Lighting System Inspection Report

Staples High School Auditorium
70 North Avenue
Westport, CT 06880

Requested By: Theodore Hunyadi
Inspection Date: October 18, 2022
Inspectors: Steve Hamelin
Jamie Burnett

Staples High School Auditorium
Inspection Report on Stage Lighting and Stage Rigging Systems
10/18/2022

F.) Proscenium Tormentor Positions

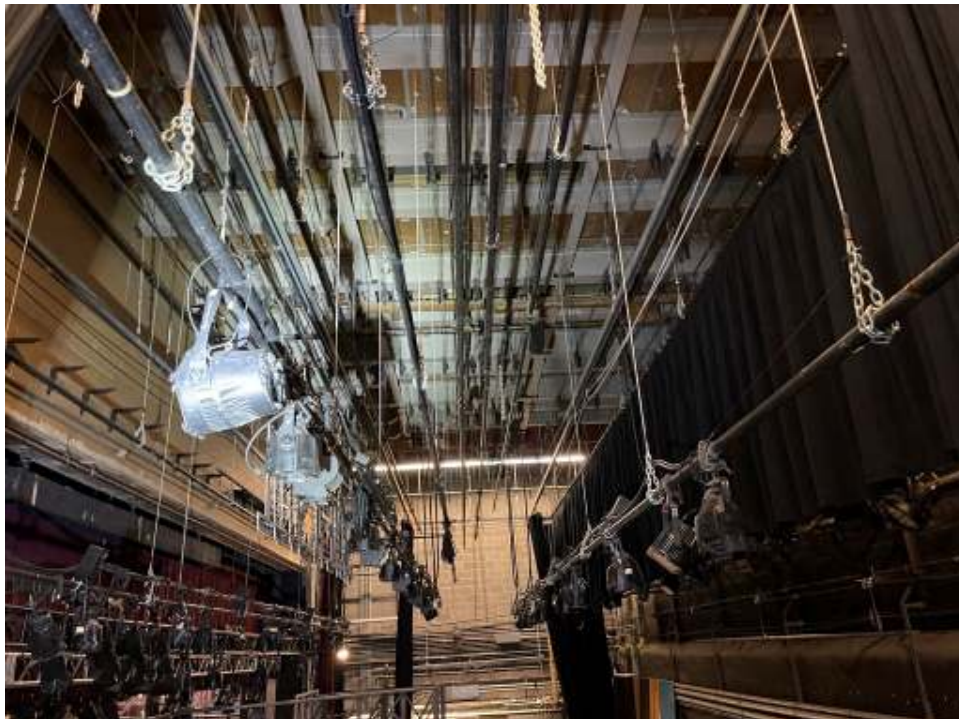
Tormentor pipes mounted to proscenium provide a useful hanging position, but they are fabricated improperly.

Recommendation: These positions should be replaced with properly fabricated single units with welded components and mounted to the floor.

H.) Dimming System

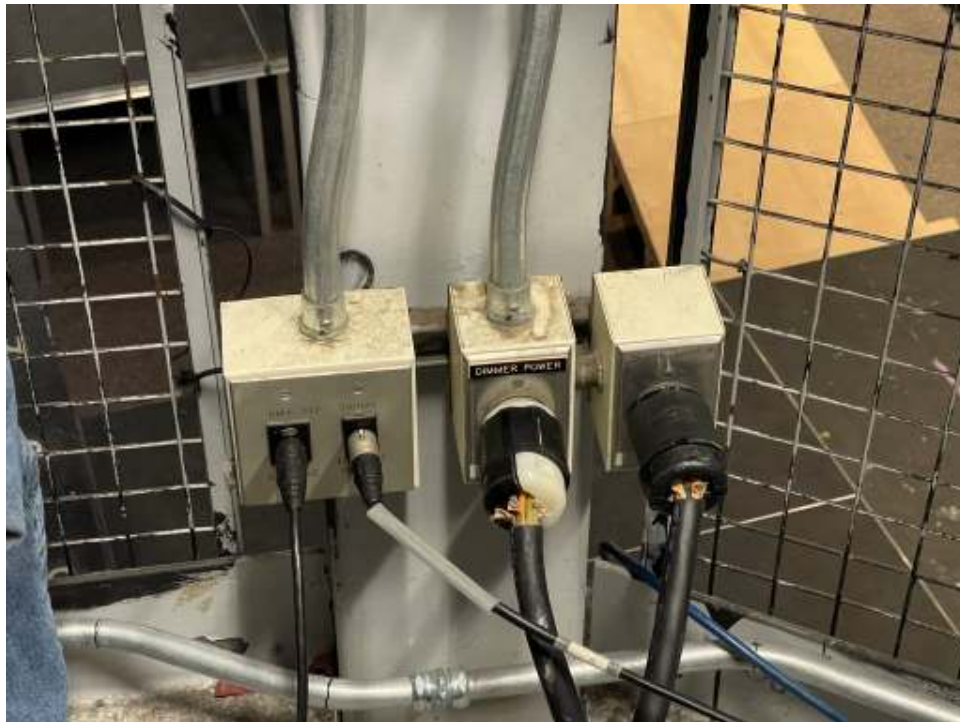
The dimming system is designed with no central dimming, except for house light dimming (addressed below). Six circuit dimmer bars are positioned throughout the space with cabling required from most positions to reach the dimmer bars. Many of the dimmer bars have connectors with strain reliefs not correctly maintained.

Many areas have dimmer bars that are not mounted. Many of the dimmer bars are located in areas that could be considered unsafe, either in terms of access to those areas or in terms of positioning to maintain safe operation and space for heat dissipation.

Recommendation: Dimming system wiring should be replaced with adequate circuits designed for an LED system. Relay racks should be supplied to allow for LED fixtures to be turned off when not in use, conserving electricity. Power distribution should be redesigned, replaced, and configured for efficient use to minimize extraneous cabling as much as possible, facilitating and speeding up deployment of new lighting plots.

J.) House Light System

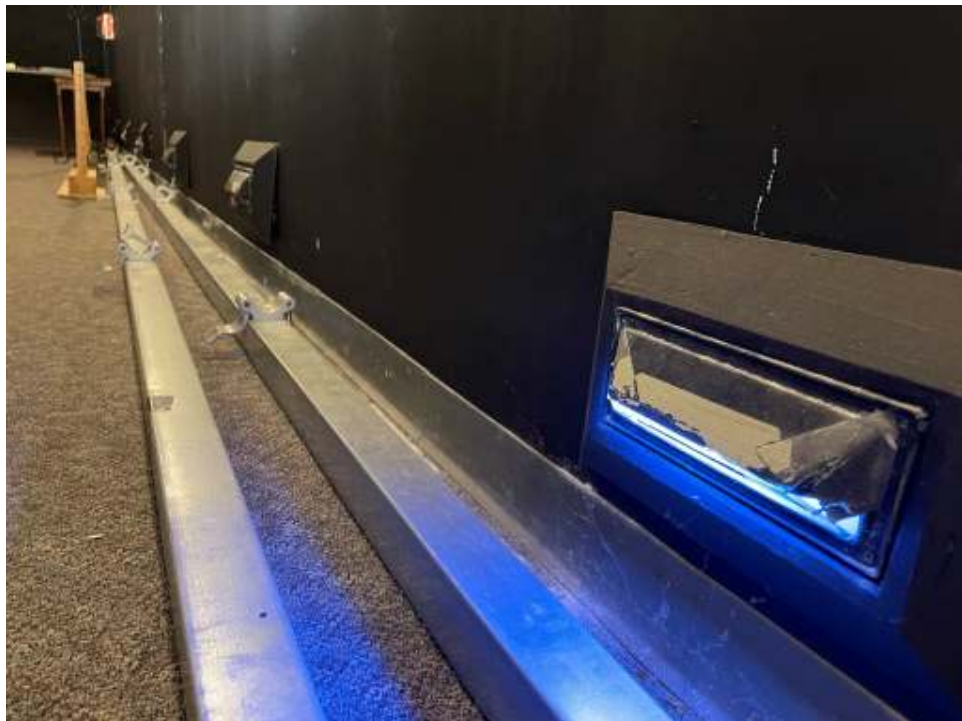
The auditorium house light system is barely functional. A number of attempts have been made to bolster the system, resulting in control issues. The house light dimming system is obsolete. Many of the control stations are inoperable.

Some house light fixtures are not connected to the lighting system at all, and therefore not controllable for performances. Many of the house light fixtures need new lamps. A pendant fly system is required to reach some of the fixtures for re-lamping.

Many areas of the house are dark, because of nonfunctioning house lights.

Aisle lighting and safety lighting is in disrepair or not working.

Detrimental glare from side sconces.

Recommendation: The house light system should be replaced in its entirety, with the dimmer units replaced by relay panels. The house lighting fixtures should be replaced with DMX controlled LED fixtures, uniform in type throughout the space to provide adequate levels of light to maintain safe egress. Pendant winches should no longer be needed, as lamp replacement should be minimal.

New house light controls, compatible with the new house lighting system, should be provided at all entry points, and touch screens should be located in the control booth and backstage at a stage managers position to provide the ability to have limited control of the lighting without having to use the lighting control console.

Aisle lighting and egress lighting should be updated to provide adequate access into and out of the space when the house lights are down for performance.
